Amendments to the Drawings:

REMARKS/ARGUMENTS

Applic. No.: 10/689,671
Amdt. Dated June 20, 2005
Reply to Office action of December 20, 2004

Fig. 2A

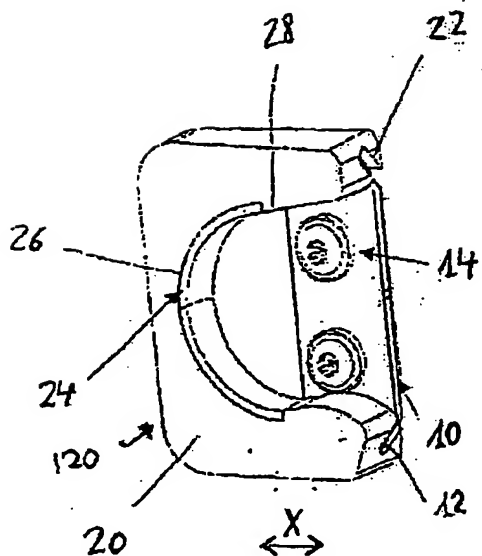
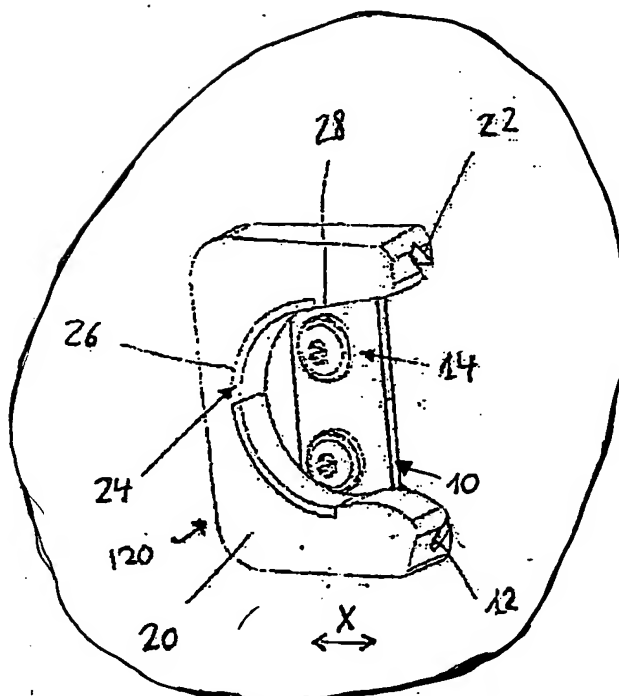
In item 1 on pages 2-3 of the above-identified Office action, the drawings have been objected to under 37 CFR 1.83(a) as not showing every feature of the invention specified in the claims.

More specifically, the Examiner has stated that the "roller receiving part which is adjustable relative to the second base plate" must be shown or the feature(s) cancelled from the claim(s).

The attached sheet of drawings includes changes to original Fig. 2. This sheet which includes Figs. 1, 2A, 2B, and 3, replaces the original sheet including Figs. 1-3. More specifically, Fig. 2 has been replaced by Figs. 2A and 2B.

Fig. 2 has been replaced with Figs. 2A and 2B to clearly show that the roller receiving part 20 is adjustable relative to the second base plate 10 (see page 6, lines 12-14 of the specification). The specification has been amended accordingly.
